Crosswear Industries Limited

Ashu/Shilpa-16, Ward-01, Kathgara, Zirabo, Ashulia, Dhaka-1341, Bangladesh
(23.916381 N, 90.294261 E)

20 February 2022

Observations

Hole in floor slab

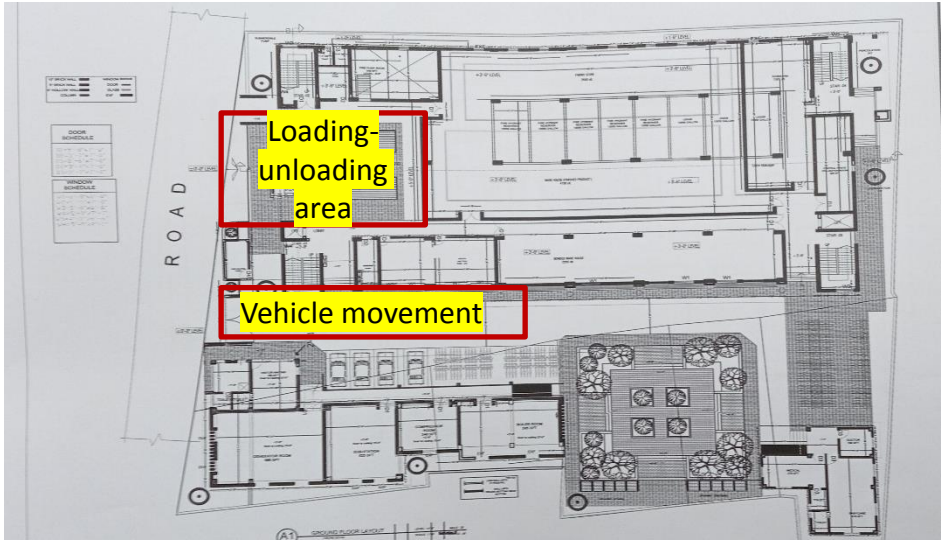
Slab holes due to pipping were observed in several locations of slab. Also, corrosion in rebar was observed. The factory is required to remove the corrosion and fill the holes as per building engineer's suggestion.

Water intrusion into the roof slab and wall

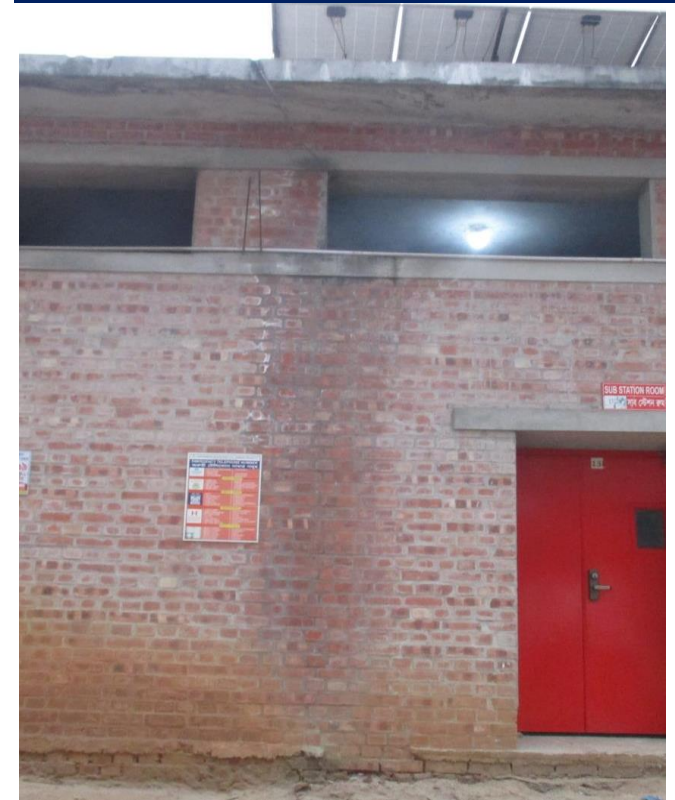
Damage due to water intrusion was observed in the roof slab and brick wall. The building engineer is required to identify the location of water intrusions and suggest remedial measures accordingly. Provide water proofing layer on the roof slab with adequate slope. Develop proper water drainage system on the roof.
